KBN Engineering & Applied Sciences, Inc.

Re: Technical Comments to the Draft BACT Determination
Prepared by FDER on the Hardee Power Station

TECHNICAL COMMENTS TO THE DRAFT BACT DETERMINATION
PREPARED BY FDER ON THE
HARDEE POWER STATION

Figure 1 FLUE GAS EQUILIBRIUM COMPOSITIONS - GAS NO. 2

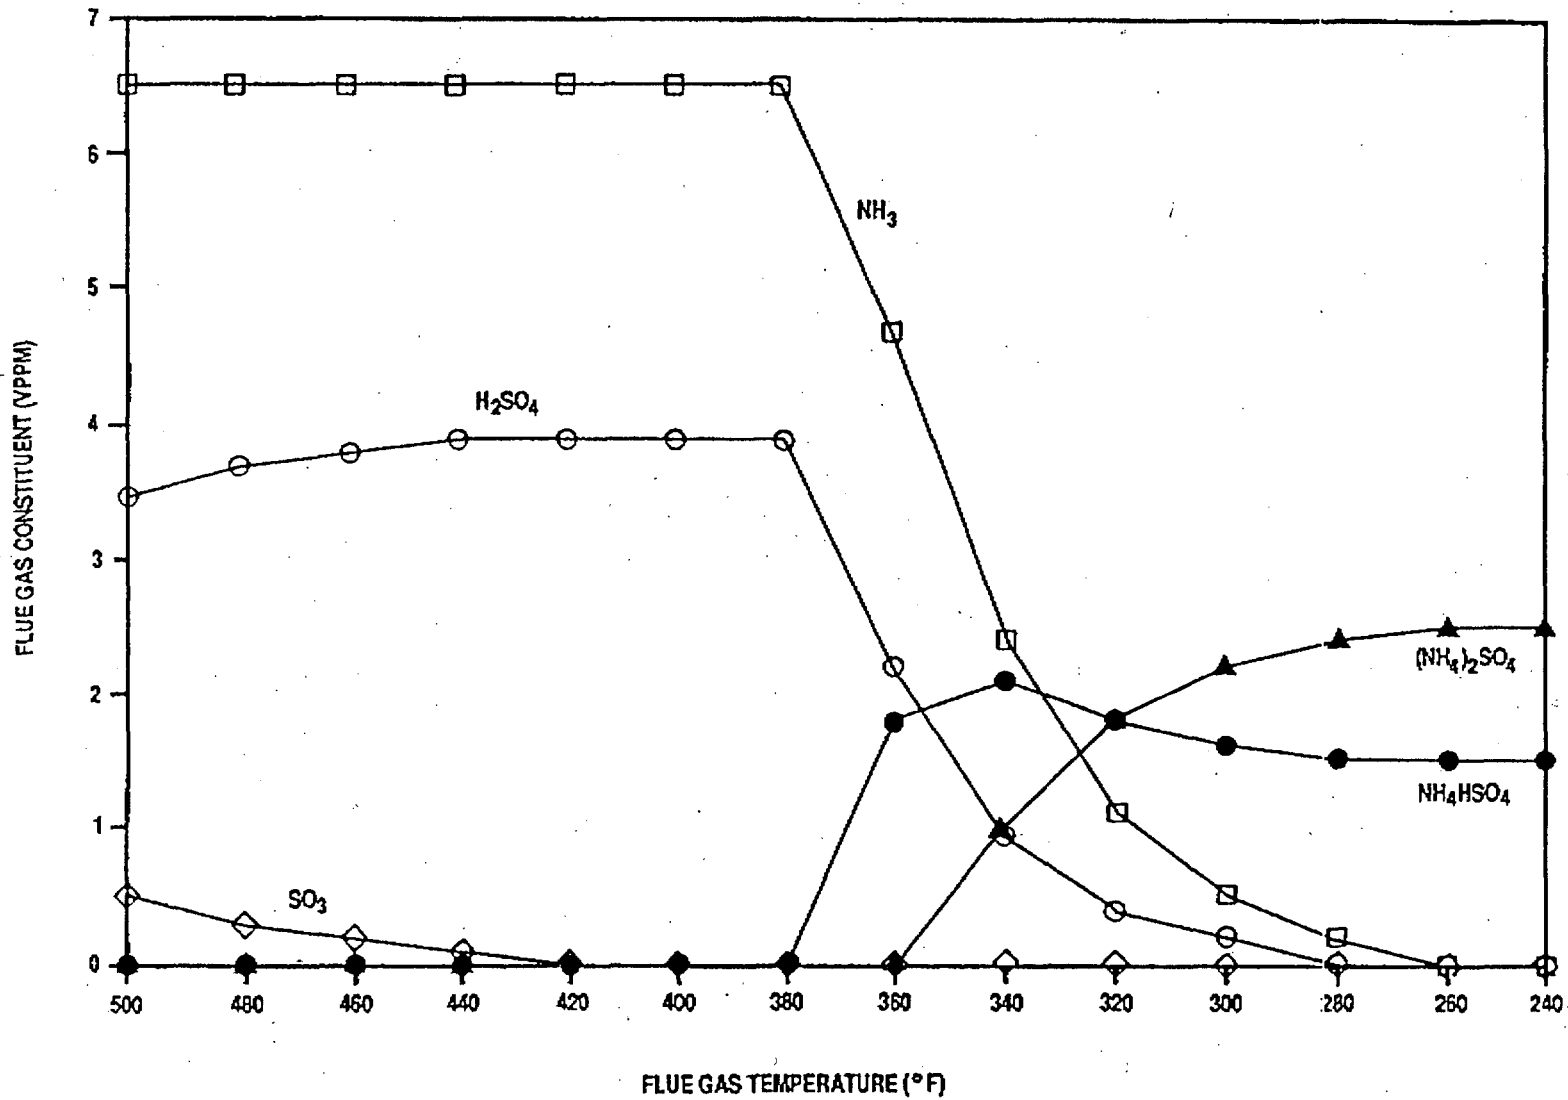
The formation of ammonium bisulfate and sulfate downstream of the SCR reactor is a complex function of gas composition and temperature. This problem was evaluated in a study recently conducted by Exxon for General Electric Company. The results of Exxon's calculations are shown in Figures 1 and 2. Both calculations used an exhaust gas composition based on firing 0.2 percent sulfur distillate oil. In Figure 1, the unreacted ammonia leaving the SCR was assumed to be 6.5 ppm, and in Figure 2 it was 13 ppm. In Figure 1, ammonium bisulfate begins to form at temperatures below 380° , and below 360° , ammonium sulfate forms as well. By the time the gas reaches 260° , all of the sulfur present as either SO_2 or as H_2SO_4 has reacted, consuming all of the excess ammonia as well. Figure 2 shows

that at the higher level of unreacted ammonia, only ammonium sulfate forms but excess ammonia in the stack gases would be 5 ppm.

Figure 2 FLUE GAS EQUILIBRIUM COMPOSITIONS - GAS NO. 1

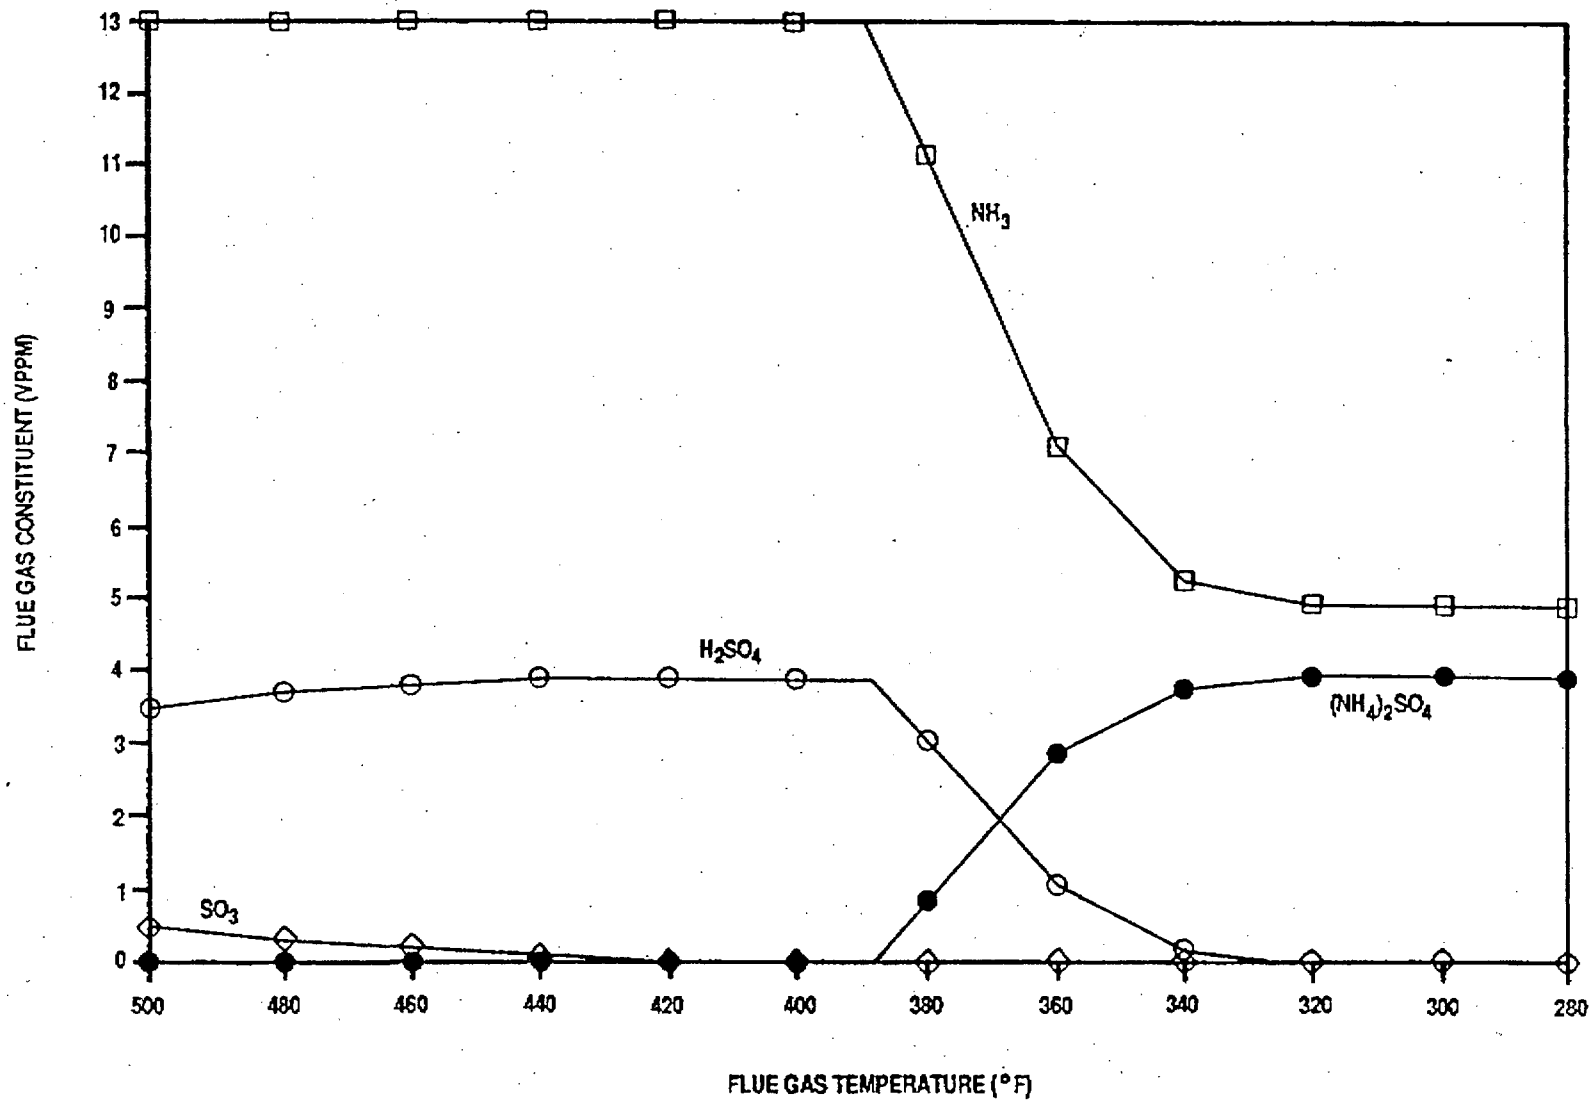
A further problem for SCR operation associated with firing sulfur-bearing fuels is the formation of particulate matter in the SCR. For the example shown in Figures 1 and 2, the sulfate particulates would increase the PM10 emissions by 49 and 55 lb/hr for each gas turbine, respectively.
